P1394a meeting minutes
July 30, 1996
San Jose CA

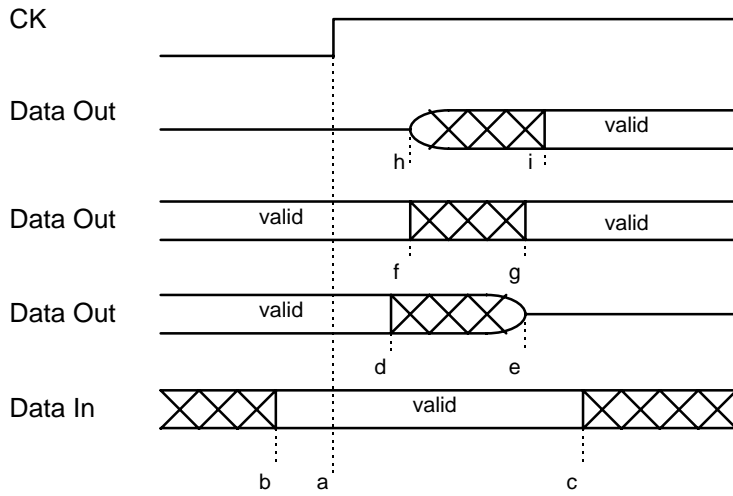
The group then discussed what is needed to change Annex J of the IEEE 1394-1995 standard from informative to normative. Table J-22, "AC Timing" needs to be reworked. It is too vague, and has some inaccuracies. Multiple companies that manufacture Phy and Link chips need to agree on the timing values, to assure that Phys and Links from different companies will work together.

In an attempt to improve table J-22, Bill Duckwall drew a timing diagram to illustrate the timing parameters that should be defined in the table. This applies equally to LREQ, DATA, and CONTROL signals.

The table in the standard should contain correct numbers in each place that nnn occurs in the above table. As noted above, manufacturers of Link and Phy chips need to discuss what the numbers should be to insure interoperability between different manufacturer's chips. We need to consider what conditions need to be specified.

***** Editor's note: The above diagram and table should be carefully reviewed since they were drawn by the editor rather than Bill (or some other hardware person). *****

min	max	units
Data Out				
tristate -> data	a-h	nnn		ns
	a-l		nnn	ns
data -> data	a-f	nnn		ns
	a-g		nnn	ns
data -> tristate	a-d	nnn		ns
	a-e		nnn	ns
Data In				
setup	b-a	nnn		ns
hold	a-c	nnn		ns
Clock				
duty cycle		nnn	nnn	%
pk to pk jitter			nnn	ns
